Access Compliance Report Public Rights-of-Way (Curb Ramps)

Main Street: BARBERRY_ST Cross Street: TUBEROSE_ST Location: SE

ADA ID: RPAT211029131927 Ramp Type: Type 4 - Parallel Initial Pass/Fail: Fail Overall Compliance: No Severity Score: 2

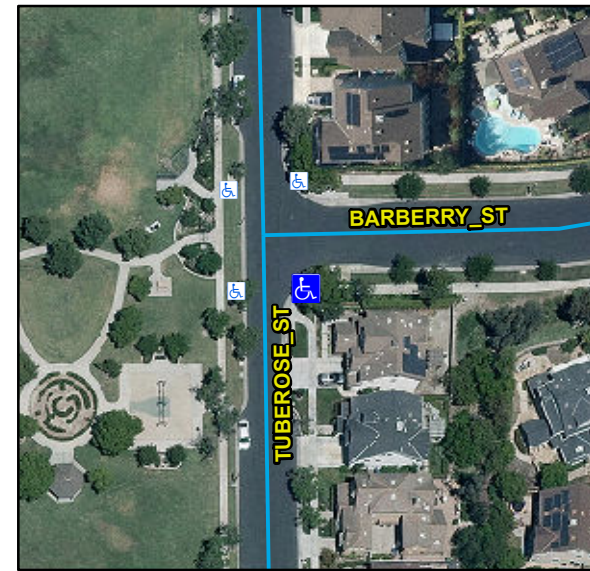
Compliance	Description	Data	Compliance	Description	Data
N/A	Ramp Length LT (in)	105	N/A	Ramp Length RT (in)	47
Yes	Ramp Width LT (in)	53	Yes	Ramp Width RT (in)	53
Yes	Ramp Run Slope LT (%)	5.6	Yes	Ramp Run Slope RT (%)	7.3
Yes	Ramp Cross Slope LT (%)	1.5	No	Ramp Cross Slope RT (%)	2.7
N/A	Landing Present	N/A	N/A	DWS Provided	N/A
N/A	Landing Length (in)	N/A	N/A	DWS Contrast	N/A
N/A	Landing Width (in)	N/A	N/A	DWS Length (in)	N/A
N/A	Landing Run Slope (%)	N/A	N/A	DWS Full Width	N/A
N/A	Landing Cross Slope (%)	N/A		DWS Offset Type	N/A
N/A	Landing Movement Obstructed?	N/A	N/A	DWS Offset Left (in)	N/A
	Landing Movement Type	N/A	N/A	DWS Offset Right (in)	N/A
N/A	Landing Shared	N/A			
N/A	Clear Space	Yes			
N/A	Clear Space To Crosswalk (in)	N/A			
N/A	Marked Crosswalk 1	No	N/A	Marked Crosswalk 2	No
	Crossing 1 Direction	N		Crossing 2 Direction	W
	Marked Crosswalk 1 Width (in)	N/A		Marked Crosswalk 2 Width (in)	N/A

Possible Solutions:

Remove & Replace Curb Ramp With Two New Directional Ramps or Equivalent.
